STAFF REPORT FOR THE HISTORIC REVIEW BOARD

FILE NUMBER: DR-16-01

REQUEST: Class II Design Review – Construct New 2-Story Mixed-Use Building

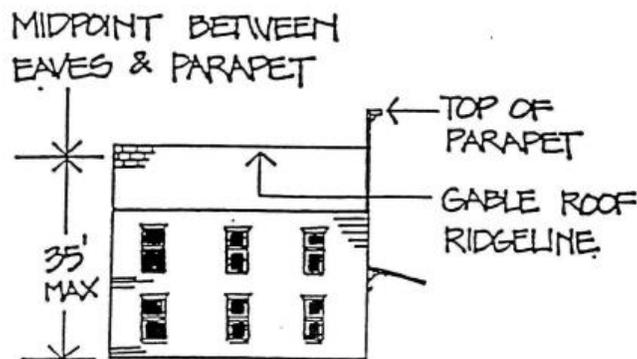
Staff Finding 4: The proposed building will cover 97 percent of the subject property. Impacts to properties on the north, east, and south are mitigated through separation by public rights-of-way. The property to the west has an existing building that has a side yard setback of 20 feet. The proposed building has a side yard setback of two-feet at this property line. The 22 feet of building separation provides adequate mitigation of impacts. This criterion is met.
